SERVICE BULLETINE – 2008- 1

SERVICE BULLETIN SB271107

ICON CONTAINER GROMMET INSPECTION Issue Date : November 27, 2007

Technical & Safety Bulletin No.	2/2007	W.N. 13
Date of Issue	12 December 2007	
Subject Matter 1	<p>Aerodyne Research Service Bulletin SB271107, dated 27 November 2007, 2 pages.</p> <p>Concerning – All ICON harness/Container systems, Part No. P120, manufactured after and including 01 September 2007</p> <p>Reason – Damage to grommets on an ICON contained; damage having been caused by the grommet press.</p> <p>Status of Bulletin – Precautionary. The incident may have been an isolated one but as a precautionary measure Aerodyne is recommending that all grommets on systems noted above be inspected.</p> <p>Attached – A copy of the Aerodyne Service Bulletin SB271107, in PDF format, is appended with this IPC Safety Bulletin.</p>

Pictures:

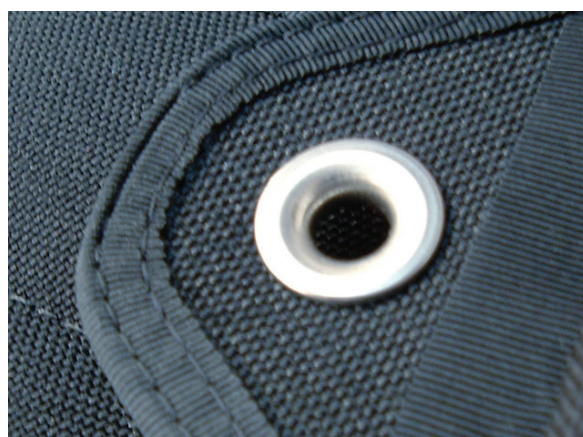
The Damage can be seen on the inside of the Grommet where the Closing Tool has scratched the Inside Surface of the Grommet. The seating of the Grommet needs to be inspected to ensure correct and flush seating of the Grommet.

1. Damaged Grommet
see damage on inner ring of grommet

1. Undamaged Grommet

This could well be an isolated incident, but as a matter of precaution Aerodyne is recommending all Grommets on the ICONs listed in the Identification paragraph above be Inspected.
